**STATEMENT OF ENVIRONMENTAL EFFECTS**  
**23-43 and 45 Tattersall Road, Kings Park**

Proposed minor changes to approved Kings Park  
Metal recovery, Processing and Recycling Facility  
via modification under Section 96(1A) to  
Development Application No. SSD 5041

August 2016

**BUILDING "L"** PROPOSED NON-FERROUS PROCESSING BUILDING

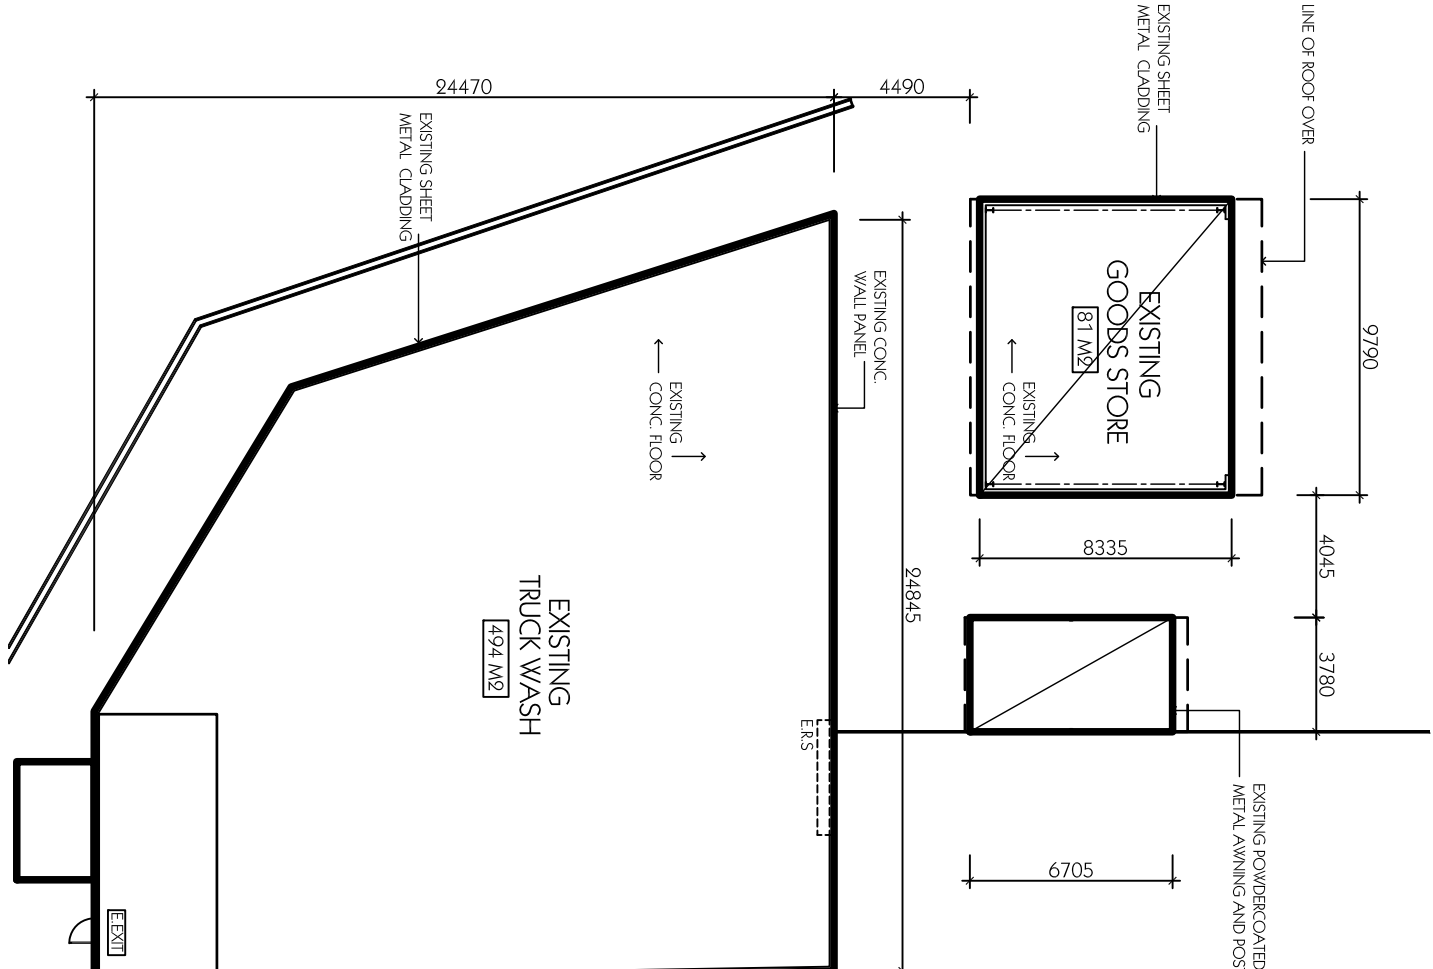
- iv. The height of "Building L" which is to enclose the existing recycling plant is to increase by approximately 5m. The reference to the building being 10 metres in the drawing information submitted with the original SSD application was an error. The purpose of this building is to enclose the existing plant to provide for improved acoustic attenuation on site. The existing plant is not proposed to be modified but rather merely enclosed in a building in which it must fit, the existing plant is taller than 10 metres and thus this was an error in the original application which the applicant now seeks to rectify. Visually, while the building may be visible from Tattersall Road, the existing plant is currently visible and could be described as somewhat of an "eye-sore". While the proposed building is taller than 10 metres it nonetheless would still enclose the existing plant which would improve the streetscape and mitigate noise impacts on adjoining properties which were assessed as an improvement in the original application;

The proposal seeks the modification of the height of the acoustic enclosure of the existing processing plant from 10m in height to 15m in height adjacent to the Tattersall Road frontage.

As previously discussed, the reason for this change is so as the existing plant can be fully enclosed, and the height of the existing plant is greater than 10m, therefore the approved enclosure would not serve its purpose. This was an oversight in the preparation of the drawings which were submitted with the original application and its approval as detailed in the Development Consent issued under SSD 5041.

## **BUILDING "C"**

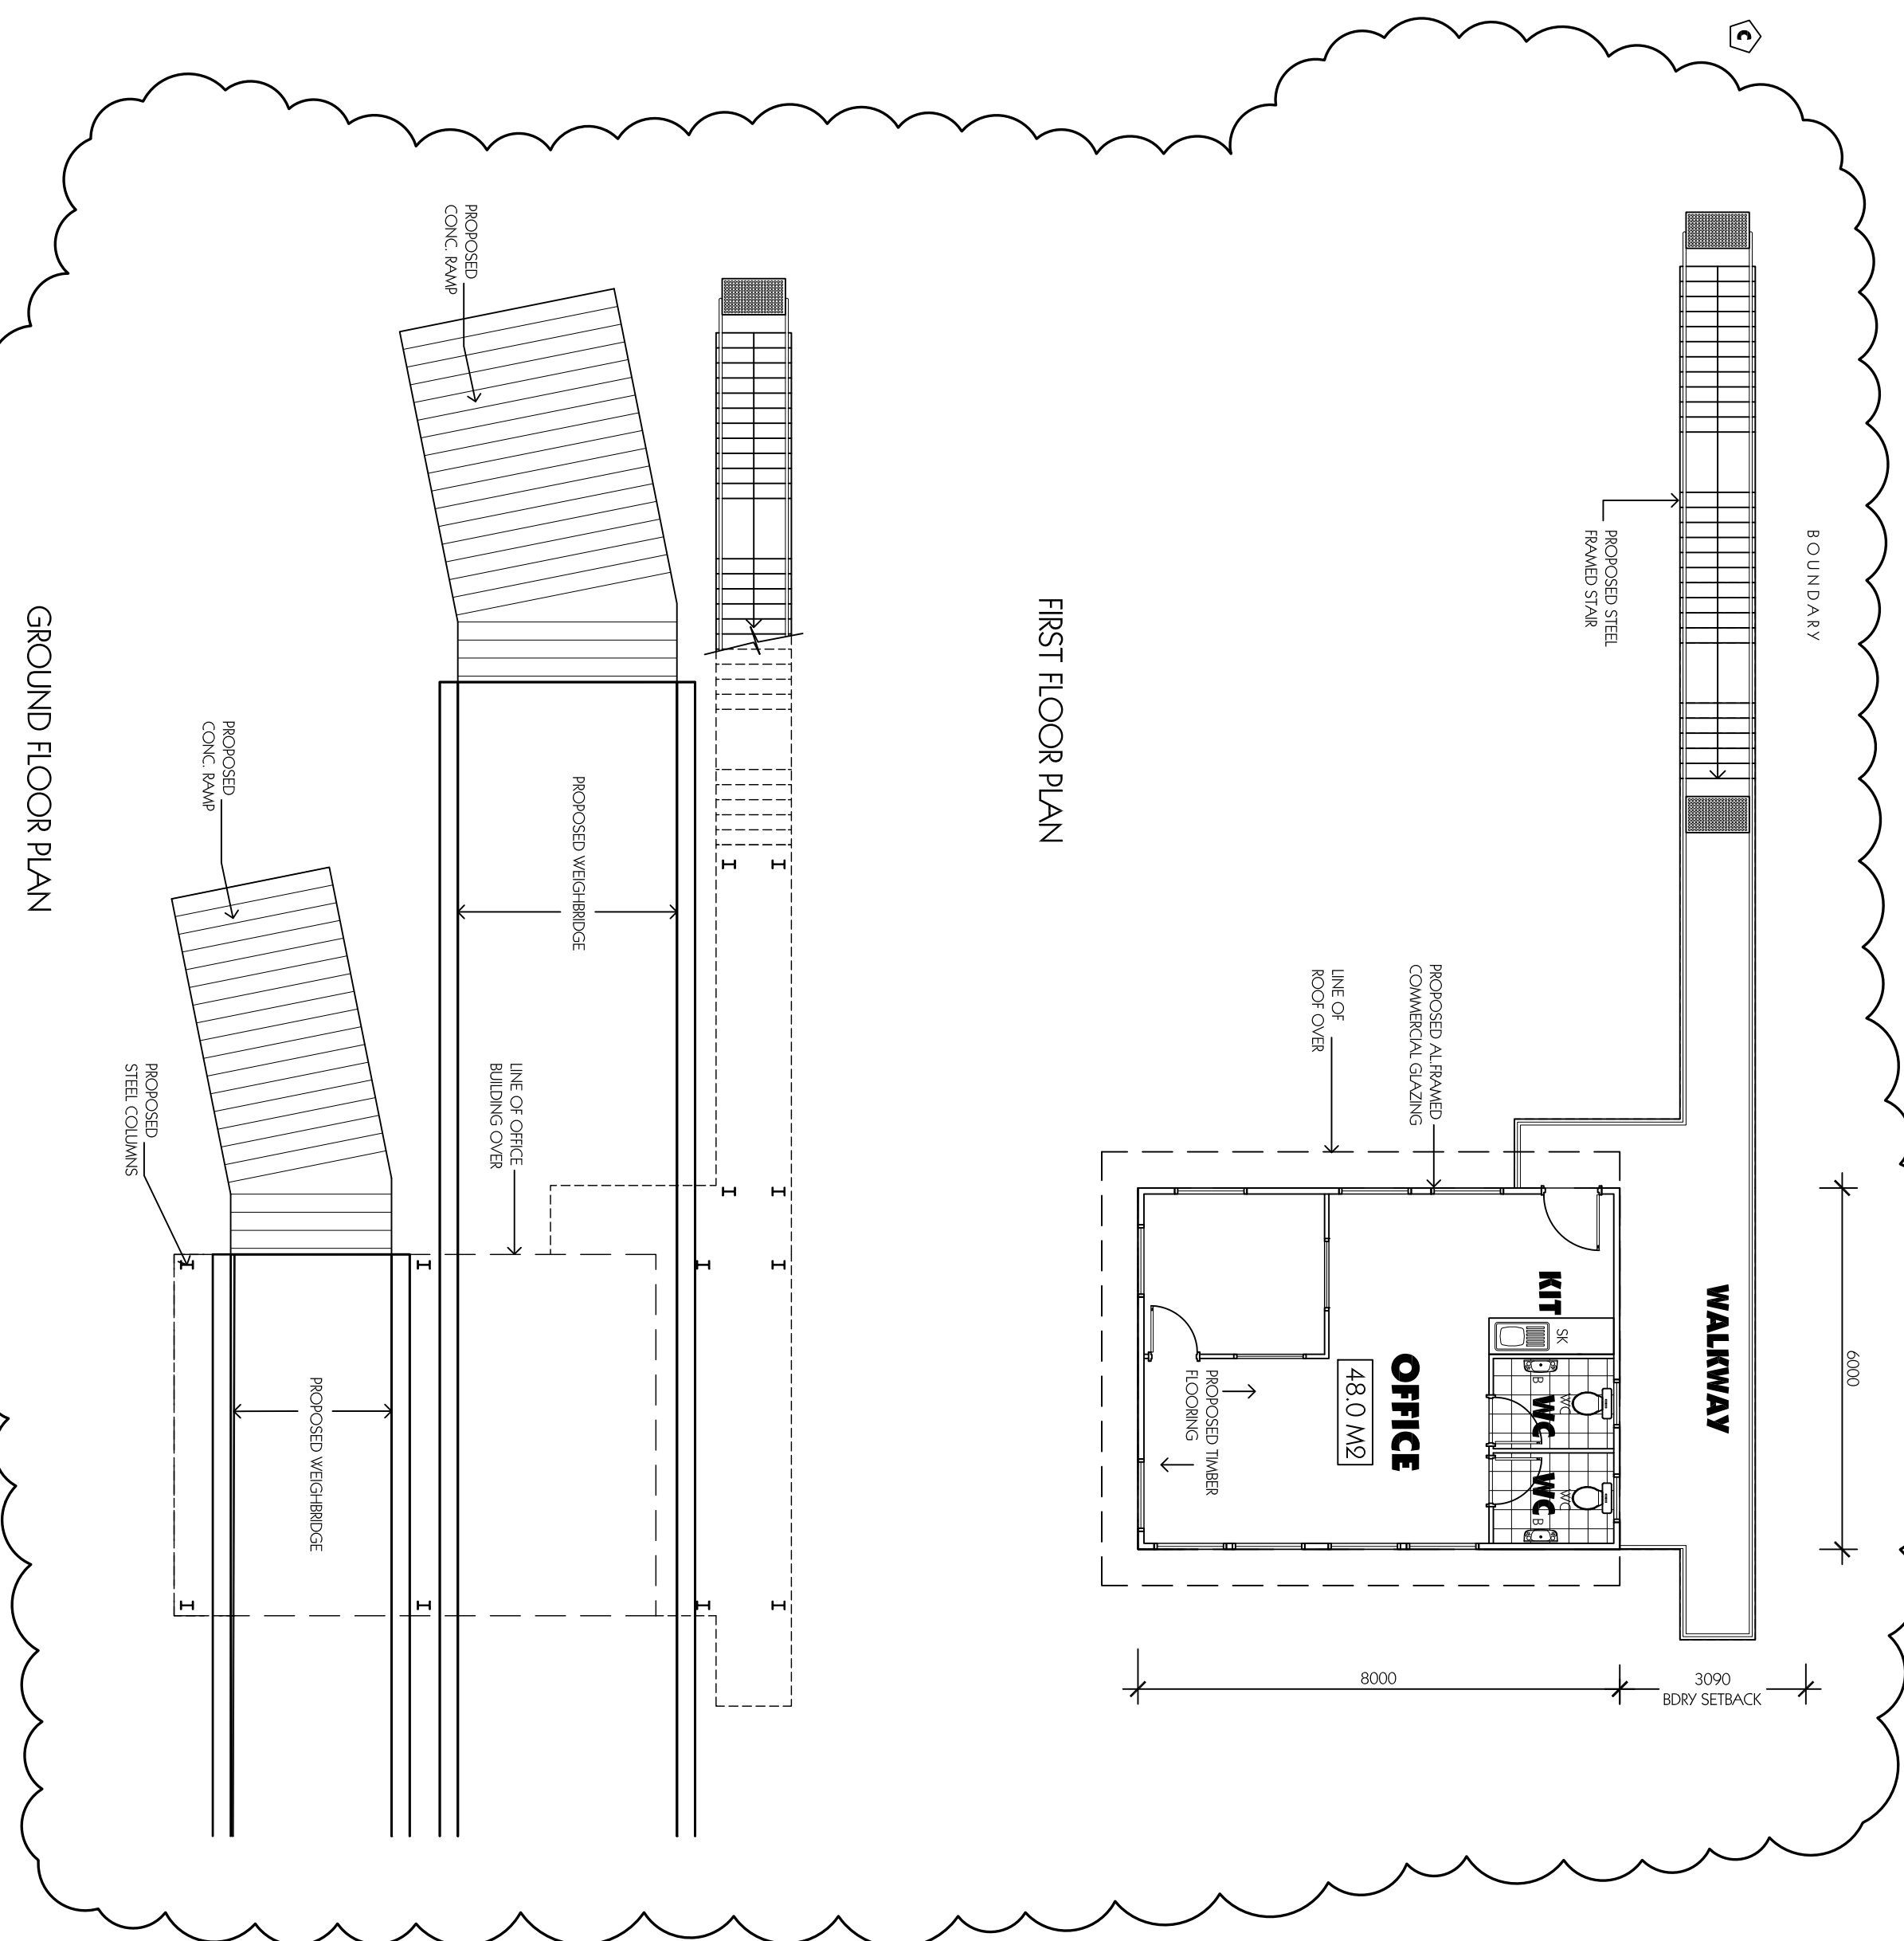
- viii. Inclusion of roller shutter door in the western elevation of Building C. The reason for the change is to enable access from Building C to the stockpiles in the recycling yard by trucks and to secure Building C when not operational;

- ix. Deletion of roller shutter door in the southern elevation of Building C. The reason for the change is this is no longer required to enable access from Building C to the stockpiles in the

- xv. Widening of an existing ramp by 1m to 1.5m wide on the eastern side elevation of Building C;
- xvi. Installation of 5 new ‘no stopping’ signs which will be installed on either side of the entry & exit driveways on Tattersall Road. Please see drawing A101E which details the location of these proposed signs; and
